Parent Item Name: Dual High Back Seat Installation - Energy Attenuating Seat Compatible

DART SERVICE INSTRUCTION

TO AMEND INSTALLATION INSTRUCTIONS IIN-D350-689 REV. B
AND INSTRUCTIONS FOR CONTINUED AIRWORTHINESS ICA-D350-689 REV. 1

REF. TCCA STC: SH02-33
REF. FAA STC: SR01620NY
REF. EASA STC: EASA.IM.R.S.01453
REF. TCA STC: 2005S03-09

FIGURE 1: UPDATES TO CROSS SECTIONS F-F AND M-M

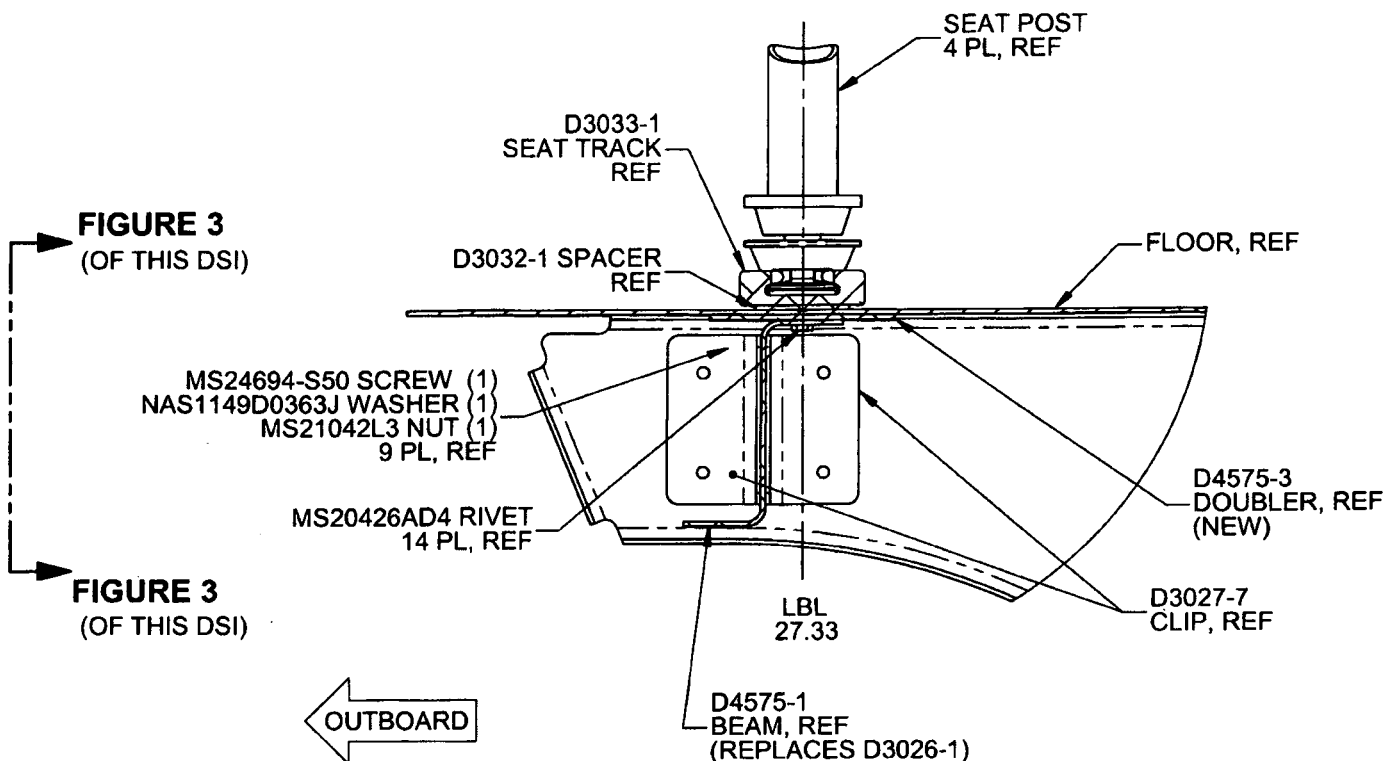
For D350-689-011/-013 at CHG 006/005 and later and D350-689-021/-023 Kits at CHG 005/004 and later, the D3026-1 Channel has been replaced with the D4575-1 Beam and D4575-3 Doubler and the D3234-3 Doubler has been removed. Consequently, the installation instructions for D350-689-011/-013 at CHG 006/005 and D350-689-021/-023 at CHG 005/004 are updated per Section 2.0 of this Service Instruction. The parts list update is shown in Section 4.0 of this Service Instruction. There is a negligible change to the weight and balance.

If there is an existing stringer at LBL 27.33, it will need to be removed from that location. Locate D4575-1 Beam, D4575-3 Doubler, and D3032-1 Spacer as shown in Figure 1 of this Service Instruction. Transfer drill existing holes from the aircraft floor to the D4575-1 Beam, D4575-3 Doubler, and D3032-1 Spacer. Ensure 1.0" to 1.5" rivet pitch and add additional holes if required. If there is no existing stringer, locate D4575-1 Beam, D4575-3 Doubler, and D3032-1 Spacer as shown in Figure 1 of this Service Instruction and drill Ø0.128" holes on a 1.0" to 1.5" pitch.

Counter sink holes in the D3032-1 Spacer for MS20426AD4 rivets. Install D4575-1 Beam, D4575-3 Doubler, and D3032-1 Spacer to floor using MS20426AD4 rivets.

FIGURE 2: UPDATES TO FIGURE 21 (IIN-D350-689) AND 25-21 (ICA-D350-689)
 With reference to Figures 19 and 20 of IIN-D350-689
 (Figures 25-19 and 25-20 of ICA-D350-689)

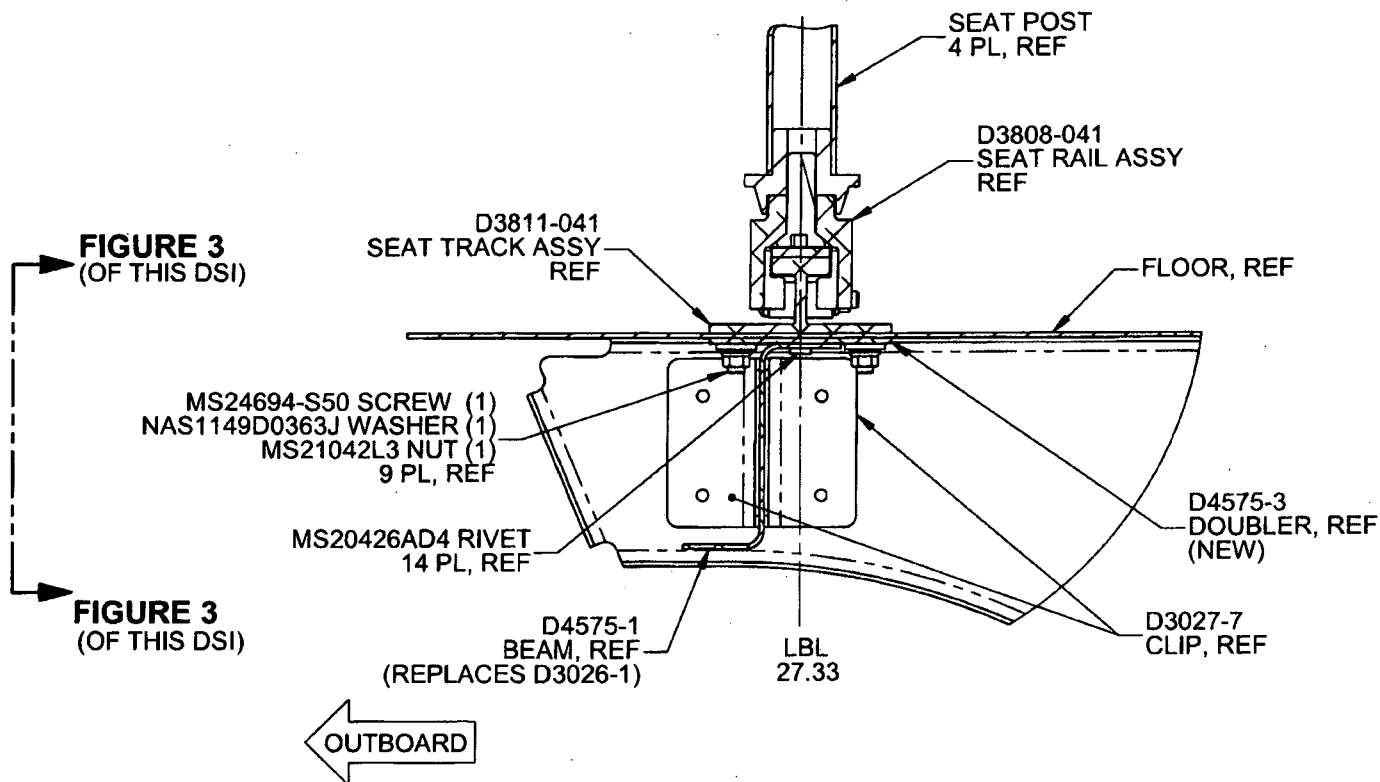
If there is an existing stringer at LBL 27.33, it will need to be removed from that location. Locate D4575-1 Beam and D4575-3 Doubler as shown in Figure 2 of this Service Instruction. Transfer drill existing holes from the aircraft floor to the D4575-1 Beam and D4575-3 Doubler. Ensure 1.0" to 1.5" rivet pitch and add additional holes if required. If there is no existing stringer, locate D4575-1 Beam and D4575-3 Doubler as shown in Figure 1 of this Service Instruction and drill Ø0.128" holes on a 1.0" to 1.5" pitch.

Attach D4575-1 Beam and D4575-3 Doubler to floor using qty (14) MS20426AD4 rivets.

FIGURE 3: RELIEFS ON D4575-1/-3
(ONLY D4575-1/-3 SHOWN FOR CLARITY)
VIEW LOOKING INBOARD

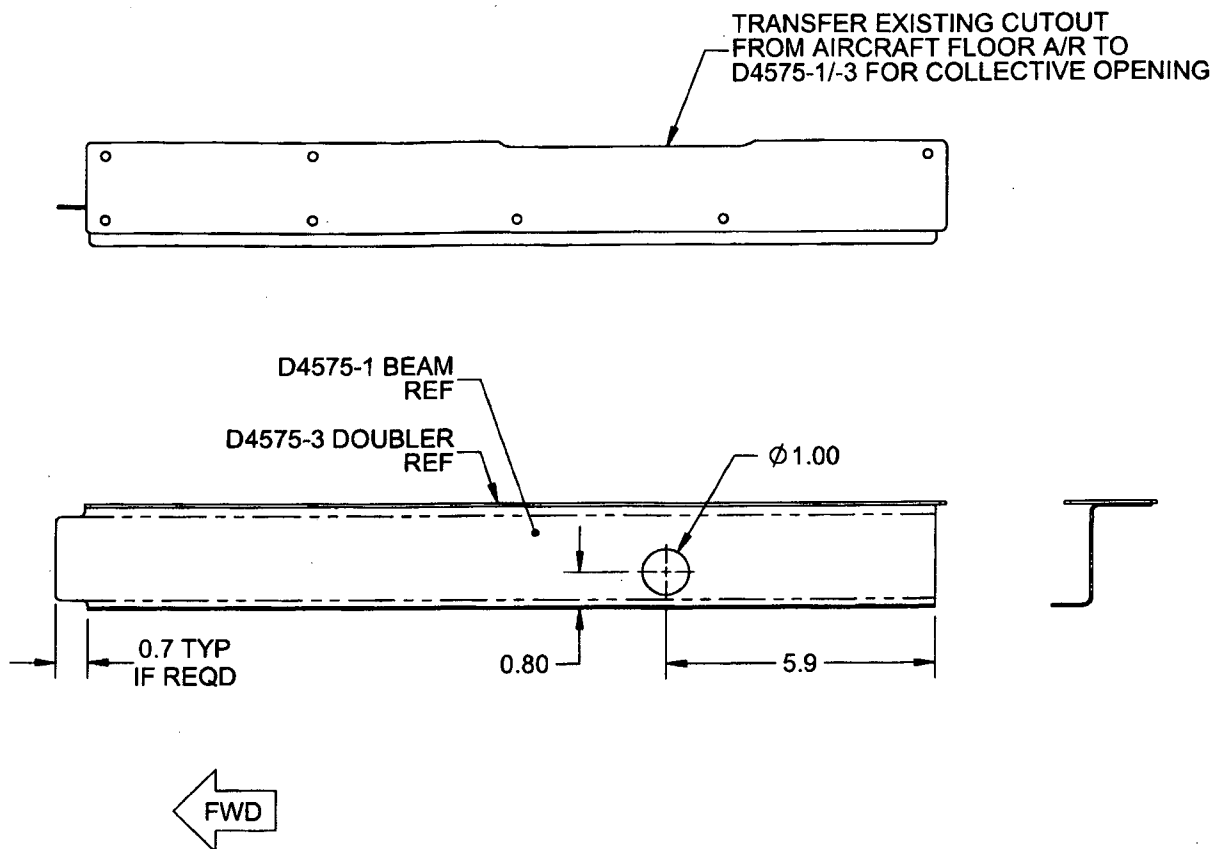
Note: Drill a Ø1.00" (Ø25.4 mm) hole in the D4575-1 Beam to clear extension tube of collective and cutout as required for clearance of collective opening and fwd bulkhead as shown in Figure 3 of this Service Instruction.

Note: Drill a Ø1.00" (Ø25.4 mm) hole in the D4575-1 Beam to clear extension tube of collective and cutout as required for clearance of collective opening and fwd bulkhead as shown in Figure 3 of this Service Instruction.
